MSEX2004A-03

S E R V I C E N O T E

MSEX2004A – Oscilloscope, Mixed Signal, 4+8 Channel,
70MHz

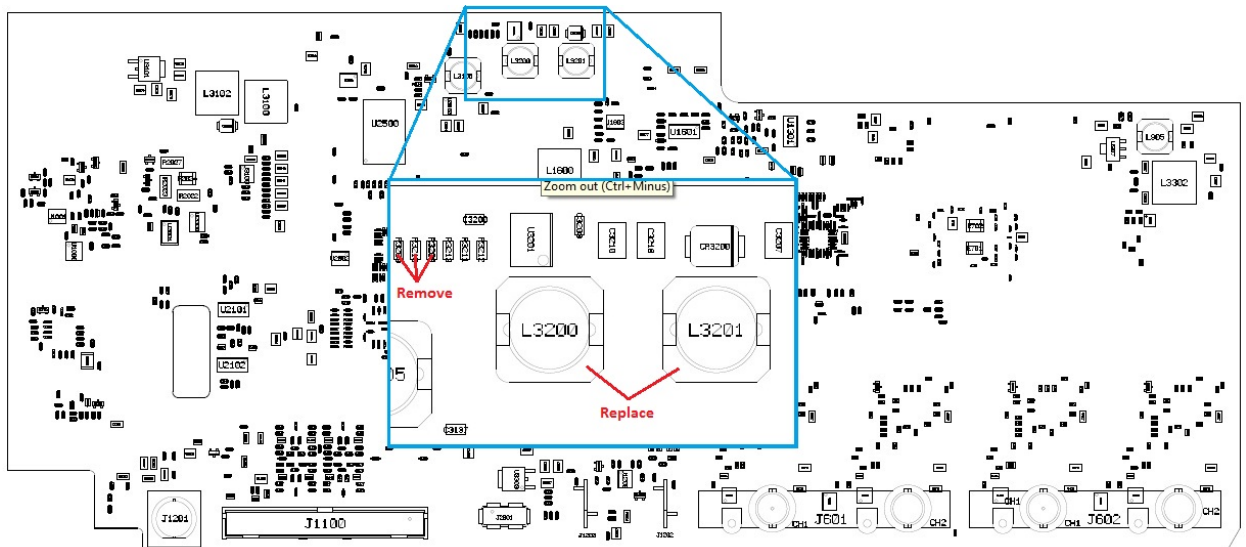
With the oscilloscope power turned on and while under normal operation, the unit emits a hissing noise.

2. As the picture indicates, remove the three resistors (0699-7209, 1 Ohm) located at R3208, R3209, and R3210. They are not to be replaced.
3. Remove as well the two inductors (9140-6474, 100uH) located at L3200 and L3201 and replace them with inductors with part number 9140-6151 (68 uH).
4. Re-assemble to the point where the unit could be powered up to verify that the hissing is indeed gone. If the hissing is not gone, please, check modifications.
5. When the hissing is gone, put oscilloscope back together.
